**STATE ENVIRONMENT IMPACT ASSESSMENT AUTHORITY,
ODISHA**

Sub: Debarment of M/s. NENO Technical Services from submitting any reports, documents to SEIAA, Odisha for obtaining Environmental Clearance-regarding.

Sub: Proposal for Amendment EC of Atigaon Sand Bed over an Area of 12.355 Acres or 5.00 Hectares in Village Atigaon under Junagarh Tahasil of Kalahandi District, Odisha - Show Cause Notice regarding.

Sub: Proposal for Amendment of Environmental Clearance (EC) for Atigaon Sand Bed over an Area of 12.355 Acres (5.00 Hectares) in Village – Atigaon, under Junagarh Tahasil of Kalahandi District, Odisha – Submission in response to Show Cause Notice.

2.0 Observation on Proposal ID: SIA/OR/MIN/532534/2025

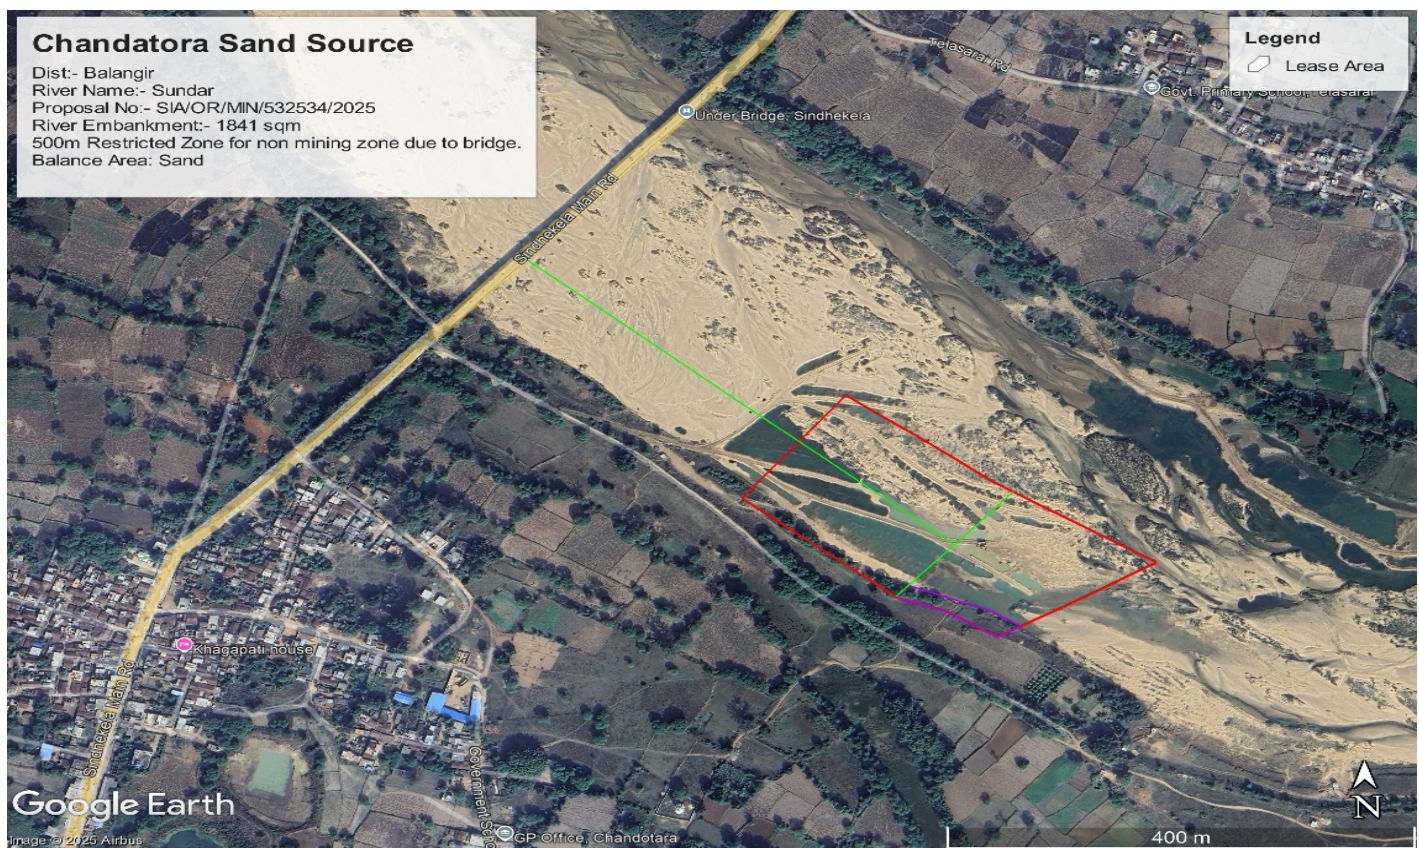
- **Lease Area: Chandatora Sand Bed**
- **Location:** Situated 500 m downstream of the Siendheikela Bridge.
- **Mining Zone Demarcation:**
 - About 70% of the lease area overlaps with the No Mining Zone (restricted area due to proximity to bridge/other regulatory constraints).
 - Only 30% of the lease area falls under the safe mining zone.
- **Replenishment Volume:** The calculation has been carried out only over the safe mining zone, yielding a replenishment potential of 8,784 Cum.

2. Sustainable extraction: The 8,784 Cum replenishment reflects the actual sustainable yield, ensuring extraction does not exceed natural deposition.
3. Regulatory compliance: Mining activities must remain confined strictly to the designated 30% safe zone.

The Chandatora sand bed on the Sunder River has a restricted workable zone due to proximity to the Siendhekela Bridge. However, within the safe mining zone, a replenishment volume of 8,784 Cum is available, making the site suitable for limited and regulated sand extraction.

3.0 Observation on Proposal ID: SIA/OR/MIN/540989/2025

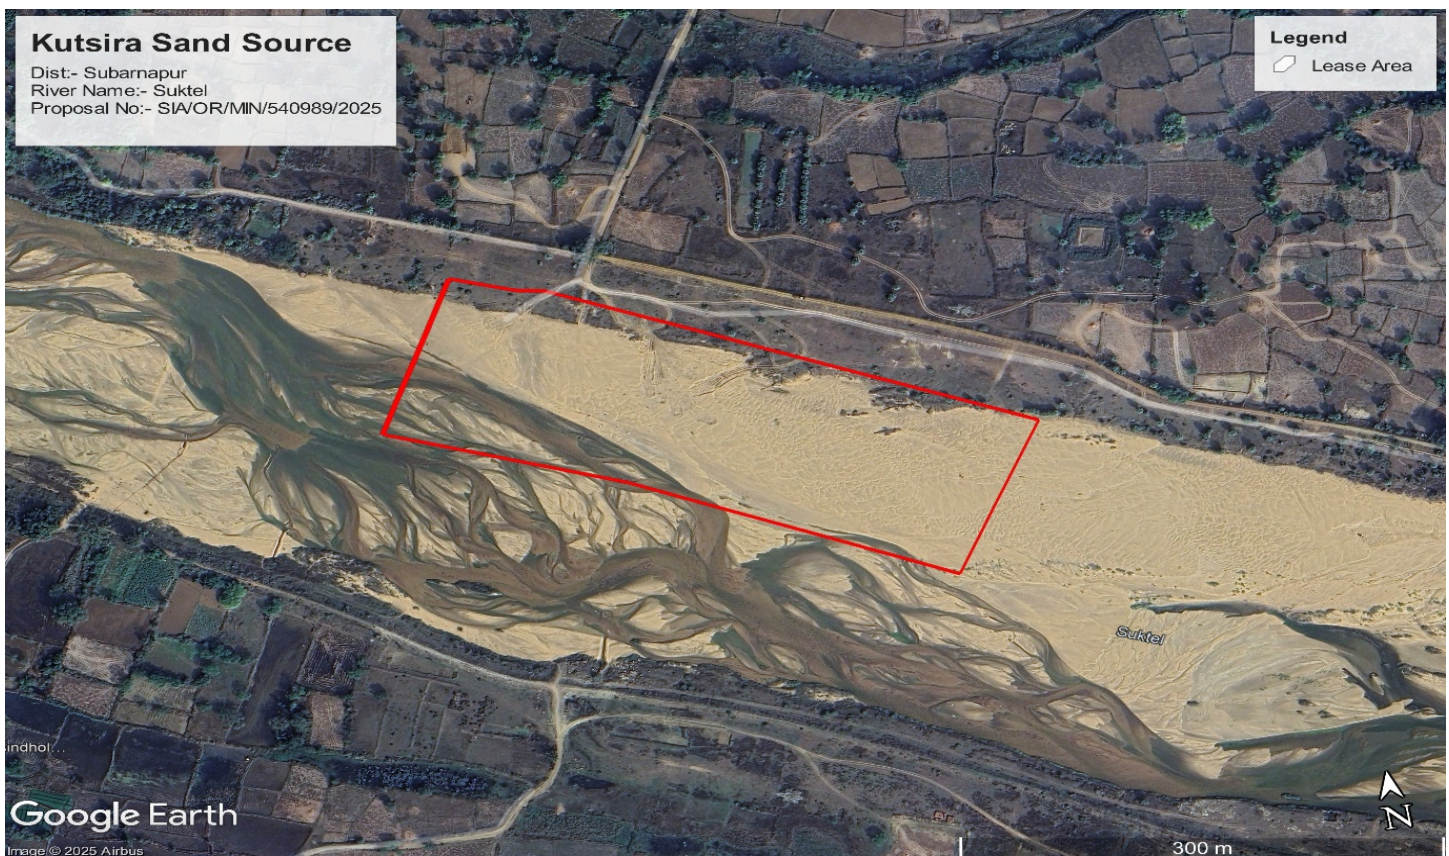
- **Lease Area:** Kutasira Sand Quarry, Suktel River.
- **Location & Setting:** The lease area lies within the mainstream channel flow of the Suktel River.
- **River Stage:** At this location, the Suktel River is in a mature (old) stage of fluvial development, characterized by a broad river channel and steady discharge regime.
- **Sediment Dynamics:** The river maintains consistent sediment transport, leading to continuous sand deposition across the channel.

1. **High replenishment:** Mainstream positioning ensures **active sand inflow and deposition**, making the site suitable for regular replenishment.
2. **Favourable geomorphology:** Broad channel and mature stage favor **stable deposition zones** rather than erosive conditions.
3. **Sustainability:** With proper monitoring, the site can support **sustainable sand extraction** without risk of over-mining.

The Kutasira Sand Quarry on the Suktel River is a **suitable lease area for sand mining**, as its position within the **mainstream flow of a mature river system** ensures **high sand deposition and continuous replenishment**.

4.0 Observation on Proposal ID: SIA/OR/MIN/541115/2025

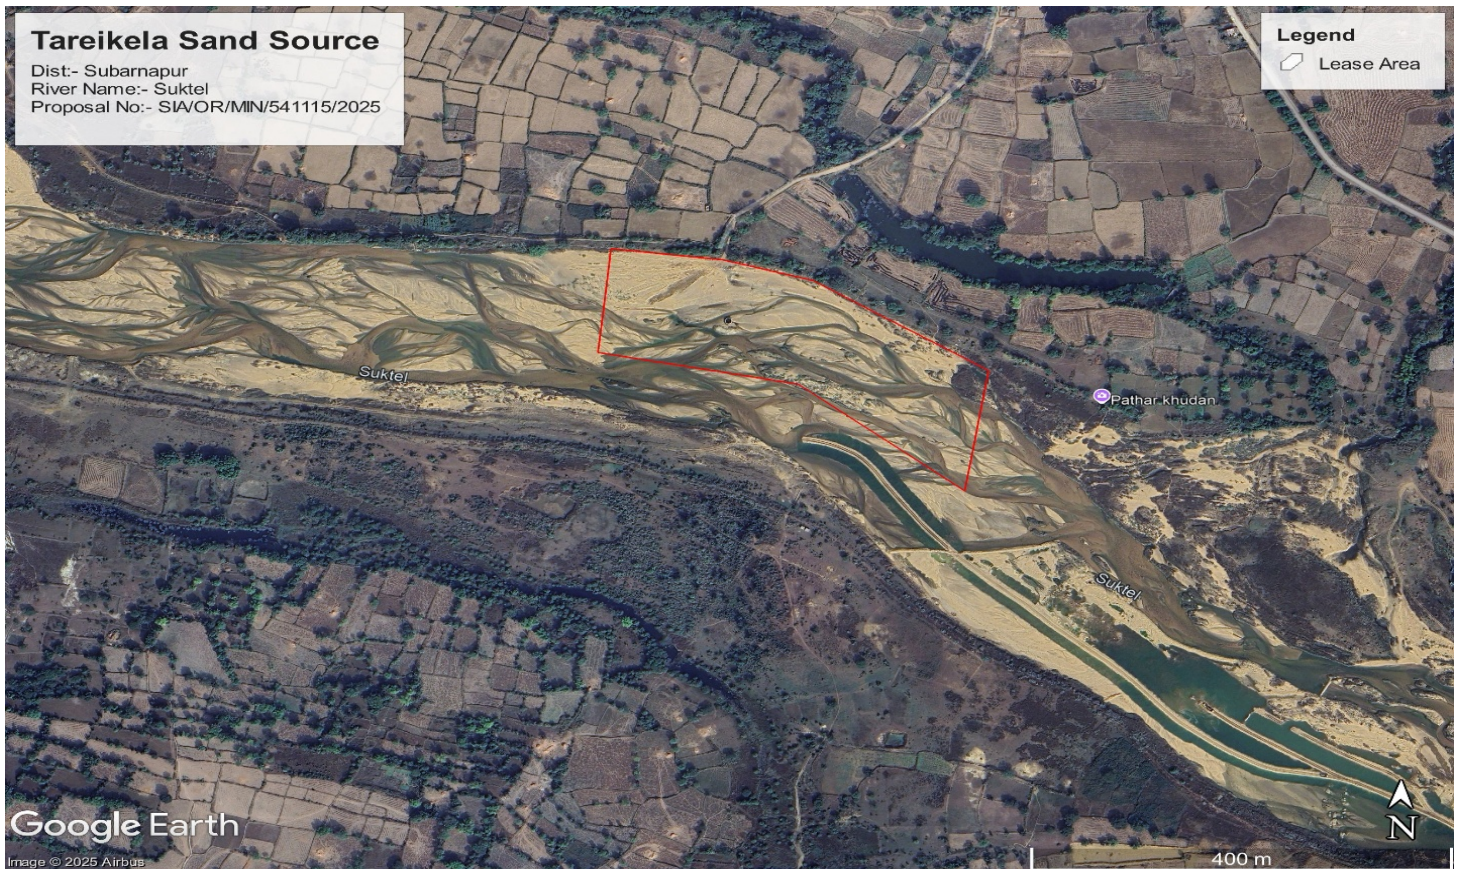
- Lease Area: Taraikela Sand Bed, Suktel River.
- Geomorphological Setting: The lease area is positioned along the inner curve of a meander, where river velocity decreases, and natural depositional processes dominate.

- Sediment Dynamics: Inner meander bends act as active sediment traps, promoting continuous sand accumulation during seasonal flows.

1. High sand deposition: The meander setting ensures abundant sediment supply and deposition.
2. Sustainable replenishment: Annual monsoon-driven flows replenish sand volumes consistently, making the site viable for regulated extraction.
3. Favourable lease area: The geomorphic advantage provides a stable and renewable sand resource compared to straight channel sections.

The Taraikela Sand Bed on the Suktel River is a suitable lease area for sand mining, as its inner meander location ensures high natural deposition and sustainable replenishment.

7.0 Clarification on Proposal ID: SIA/OR/MIN/535197/2025 (Lant River Sand Bed)

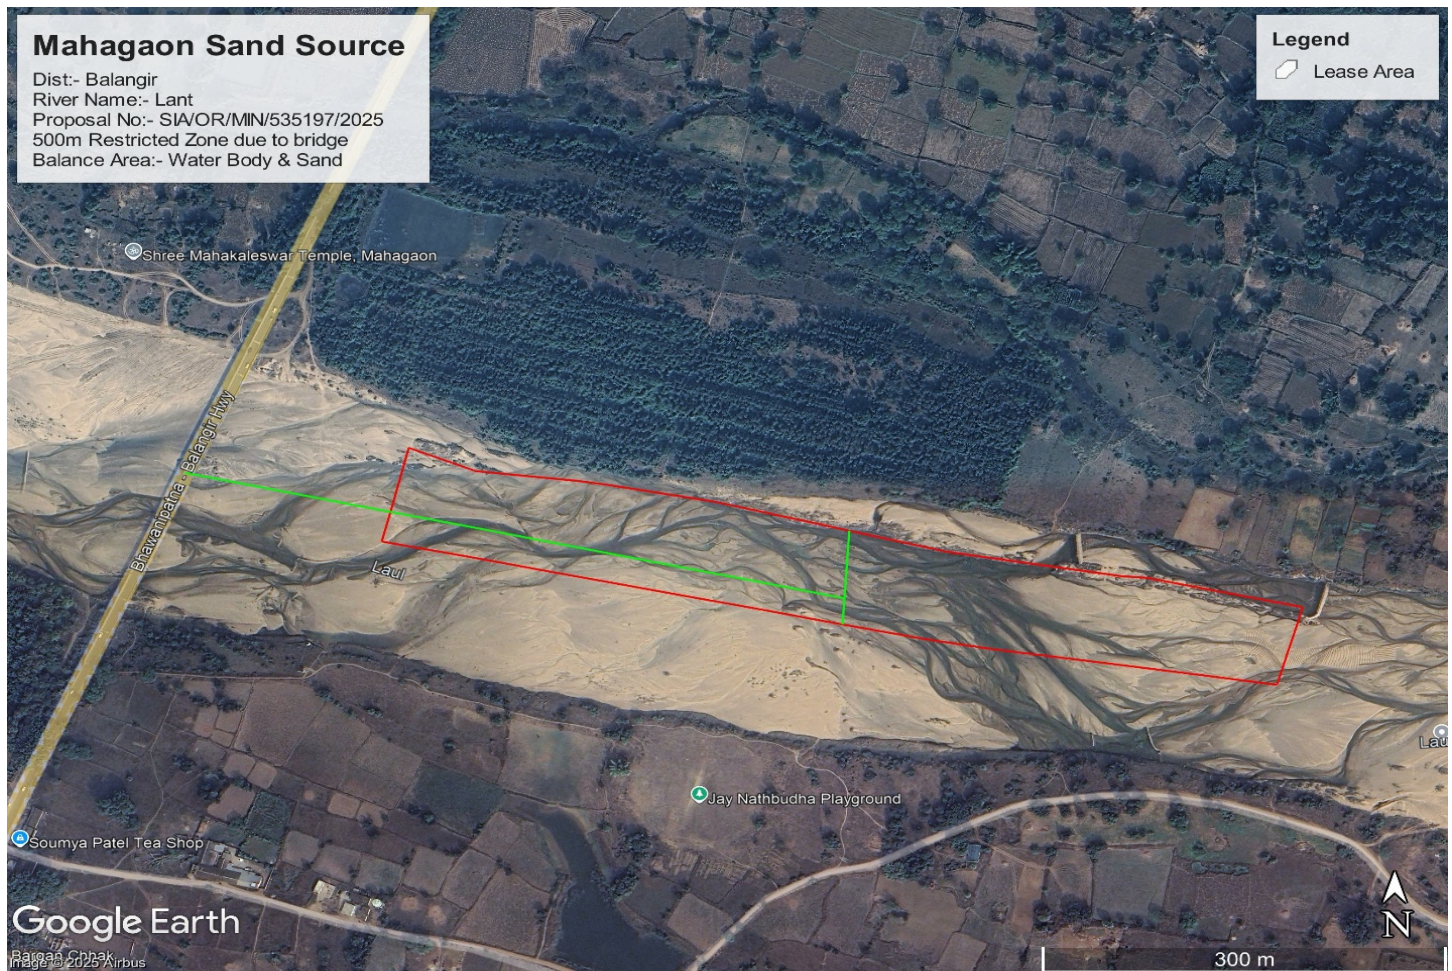
It has come to our notice that the **estimated replenishment volume of 98,880 cum** mentioned in the proposal is **erroneous**. This figure was inadvertently generated due to a **typographical mistake by our technical staff** and subsequently carried forward by the software used in preparing the report.

We acknowledge this as a **serious oversight** and sincerely **regret the error**. The actual replenishment capacity of the Lant River is considerably lower, and the incorrect figure should not be considered for evaluation.

1. **Multi-tier data verification** before submission.
2. **Cross-checking replenishment estimates** against hydrological and sediment transport data.
3. **Independent review of technical reports** prior to upload.

9.0 Observation on Proposal ID: SIA/OR/MIN/533304/2025

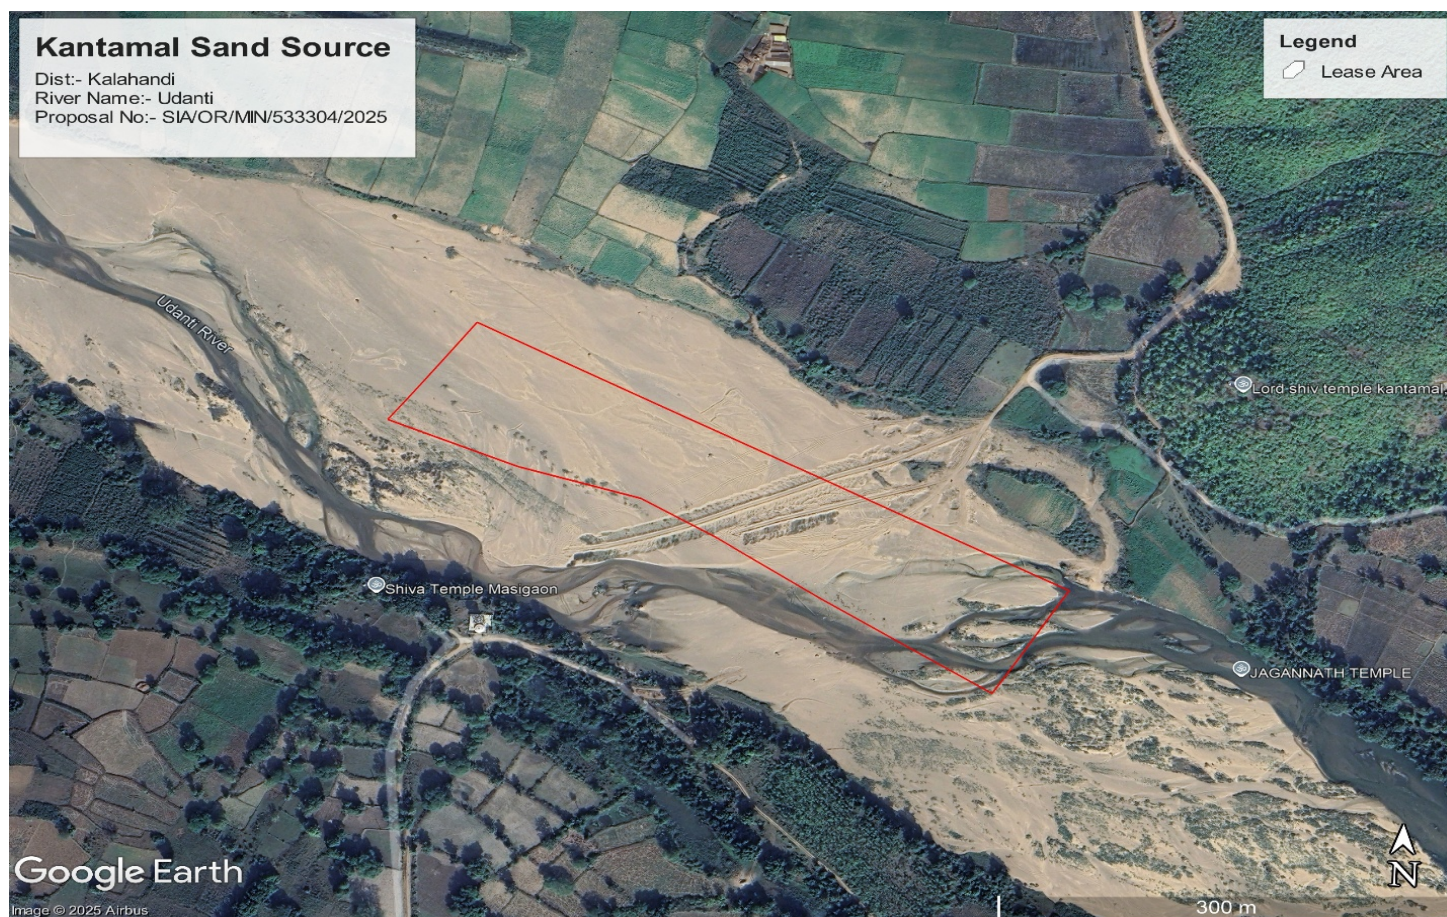
- **Lease Area:** Kantamala Sand Bed, Udanti River.

- **Sand Availability:** The site falls within a **suitable sand deposition zone**, well-connected with the active river channel.
- **Replenishment:** The lease area experiences **high natural replenishment** due to the Udanti River's sediment transport dynamics.

1. **Favourable for sustainable mining:** Since the replenishment volume is high, extraction can be balanced with natural deposition.
2. **Hydrological advantage:** The lease area is positioned within the **active floodplain**, allowing continuous sediment inflow during monsoon flows.
3. **Low environmental risk (if regulated):** With proper monitoring and scientific mining practices, the site can support extraction **without long-term depletion** of sand reserves.

The **Kantamal sand bed** under the Udanti River qualifies as a **sustainable lease area** owing to its favorable geomorphological conditions and **high replenishment rate**.

12.0 Observation on Proposal ID: SIA/OR/MIN/533568/2025

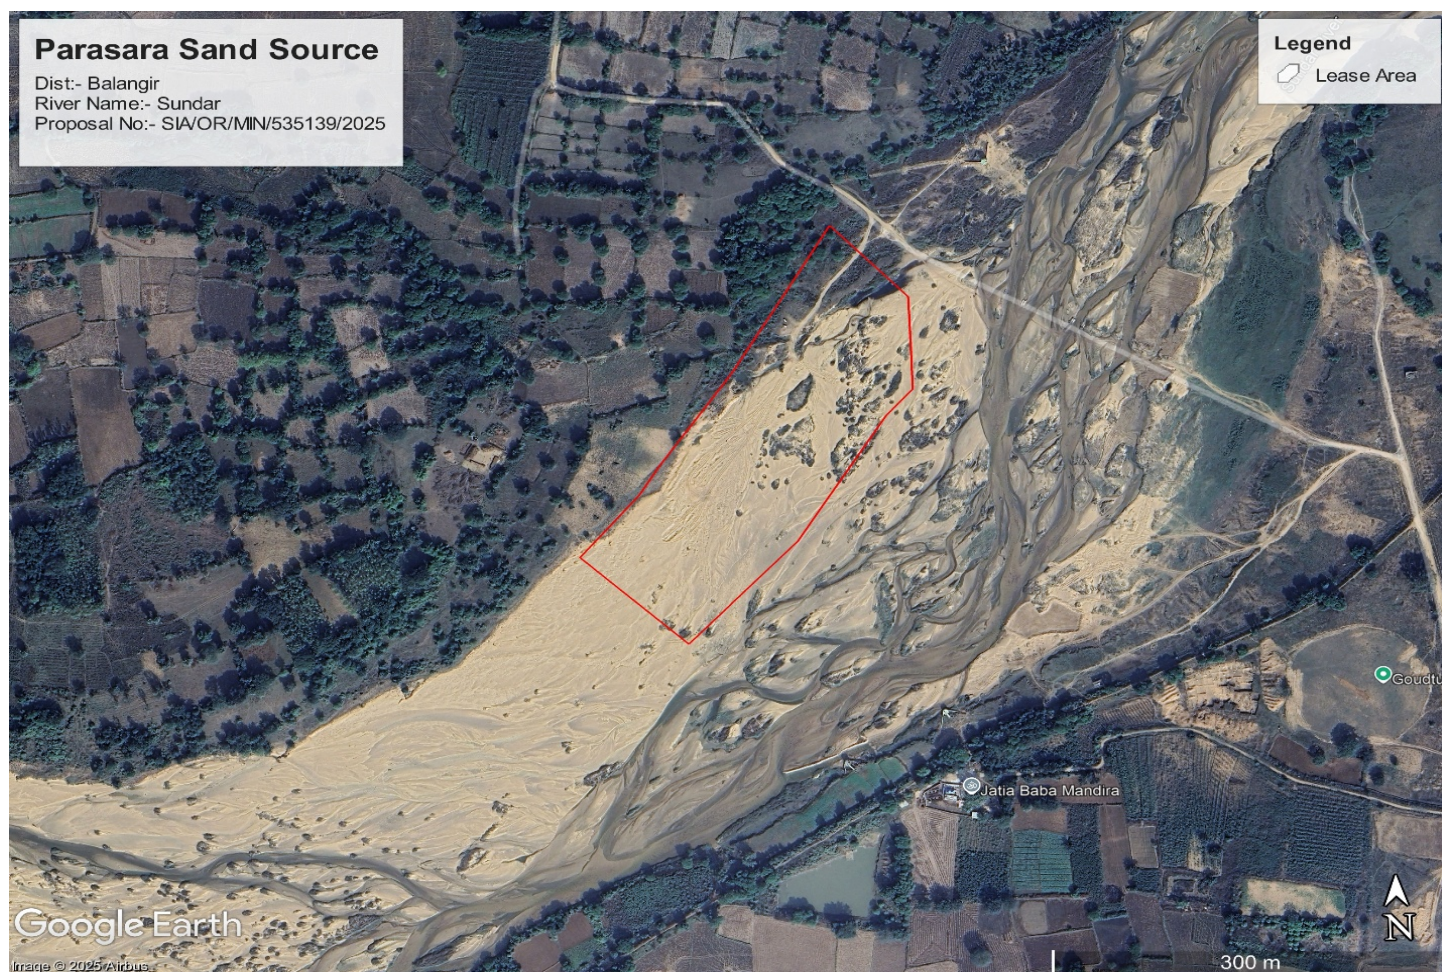
- **Lease Area:** Parasara Sand Bed, Sunder River.
- **Location:** The lease area is **adjacent to the main river stream**, ensuring direct connectivity with active sediment transport.
- **Sand Dynamics:** This positioning makes the site a **favorable deposition zone** where sediments carried during monsoon flows settle effectively.
- **Replenishment:** The **volume of replenishment is high**, indicating that the sand deposit is sustainable under regulated extraction.

1. **Sustainable resource:** The site benefits from **continuous inflow and deposition of sand**, supporting sustainable mining practices.
2. **Geomorphological advantage:** Being adjacent to the main stream ensures **active replenishment** as opposed to isolated or elevated sand patches.
3. **Suitability for mining:** High replenishment potential makes the Parasara sand bed a **viable and favorable lease area**.

The **Parasara sand bed on the Sunder River** qualifies as a **suitable site for sand mining**, as it is located beside the active river channel and experiences **high natural replenishment**.
